Wiring deltas of easYgen-3400/3500-P1/P2 versus easYgen-3400XT/3500XT-P1/P2

Clemens - 2024-09-27 - easYgen-3000XT

AC Voltage Sensing inputs:

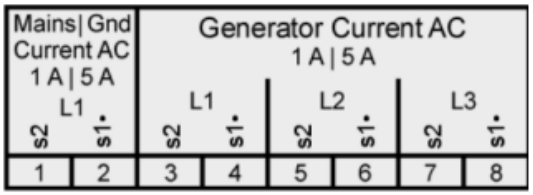
In old easYgen-3000 there are separate terminals for 120VAC and for 480VAC voltage sensing.

In easYgen-3400-XT/3500XT there is only a wide range voltage sensing input covering 120-690 VAC

Power Supply:

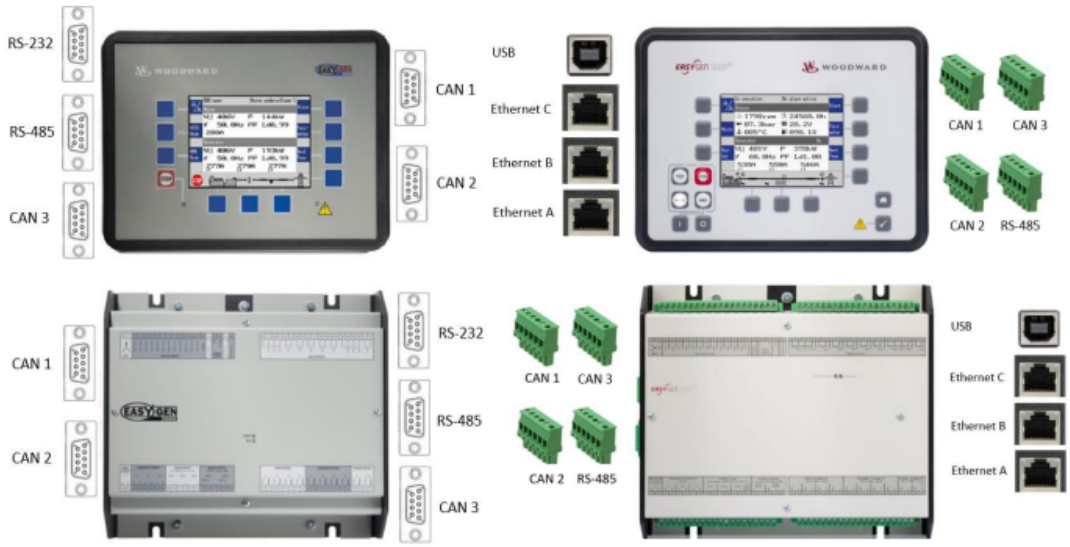
* pin 61
easYgen-3100: No connection
easYgen-3200: Protective earth

* pin 61
easYgen-3100XT-P1: No connection
easYgen-3200XT-P1: Protective earth

Terminals not used in easYgen-3400/3500

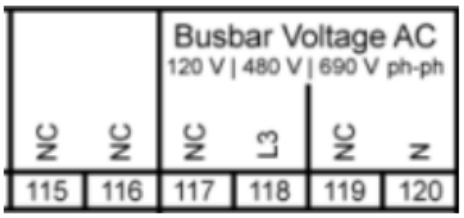
easYgen-3400XT-P2 and easYgen-3500XT-P2 has one additional Analog Output at terminal 107-108.

easYgen-3400XT-P2 and easYgen-3500XT-P2 has 3rd phase of busbar voltage sensing, which can be used for rotation check
